REPLACEMENT DRAWING

AMENDMENTS TO THE DRAWINGS

FIG. 16

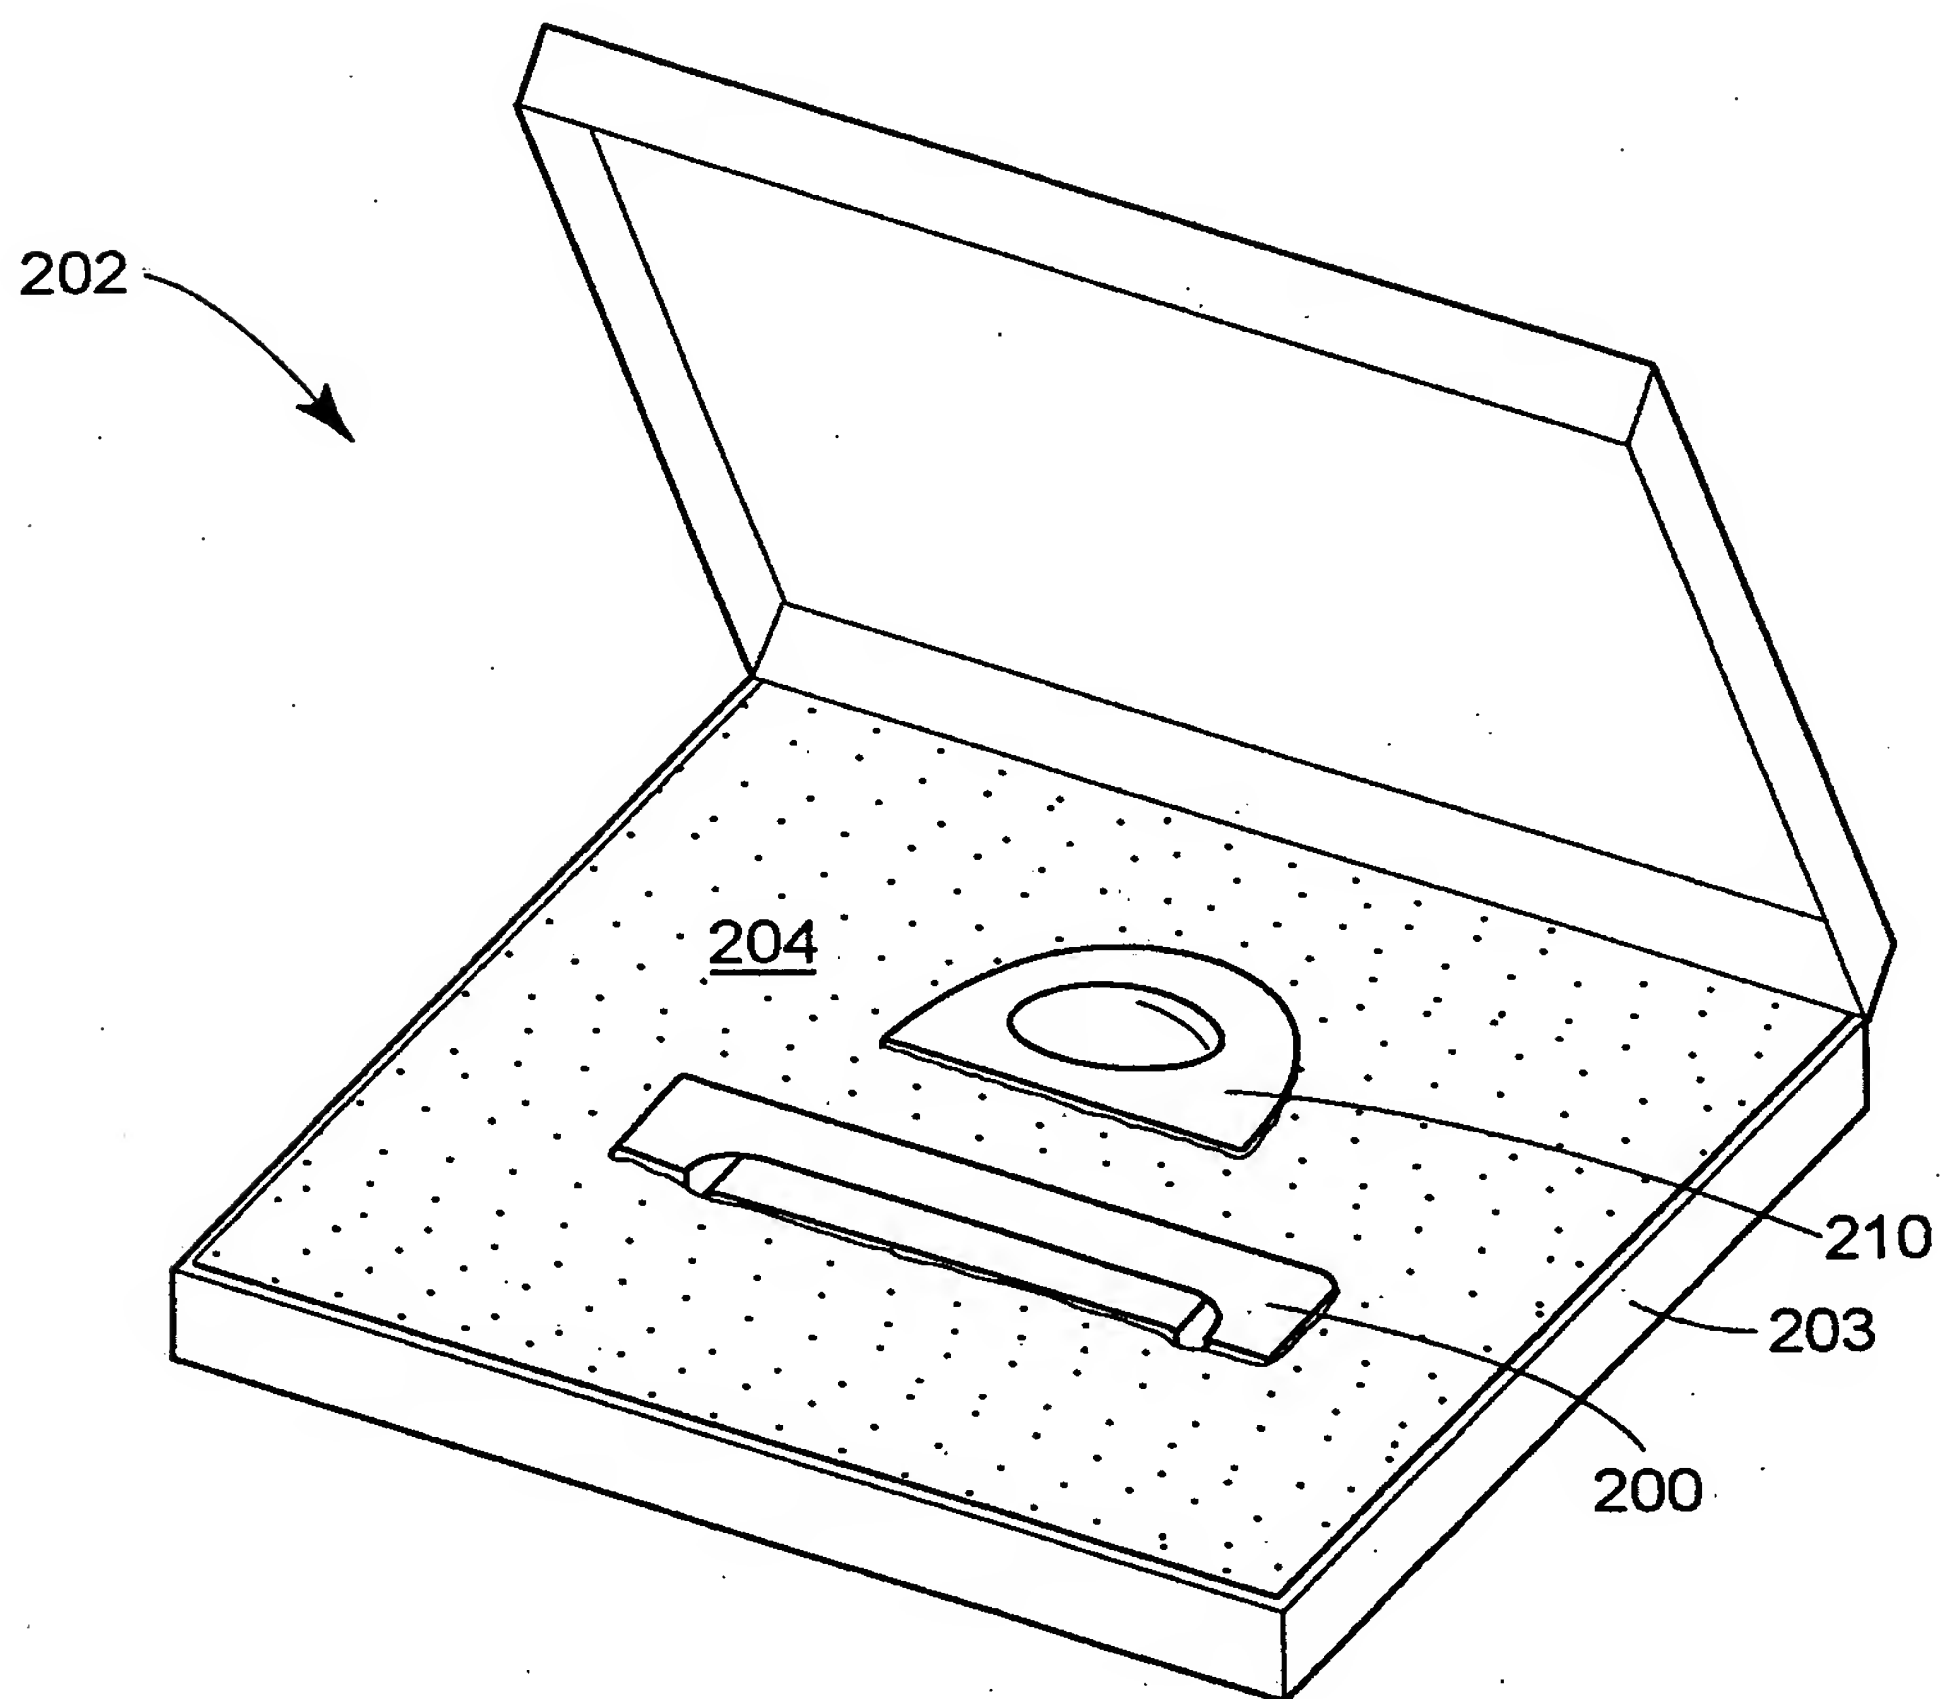
Please amend the drawings by entering the replacement sheets attached hereto. Specifically, FIG. 16 is added showing a kit 202 including a container 203 containing a base 200 and a light generating device or a leveling device 210. Support for the amendment to the drawings may be found at least in claims 48 and 59 as originally filed.
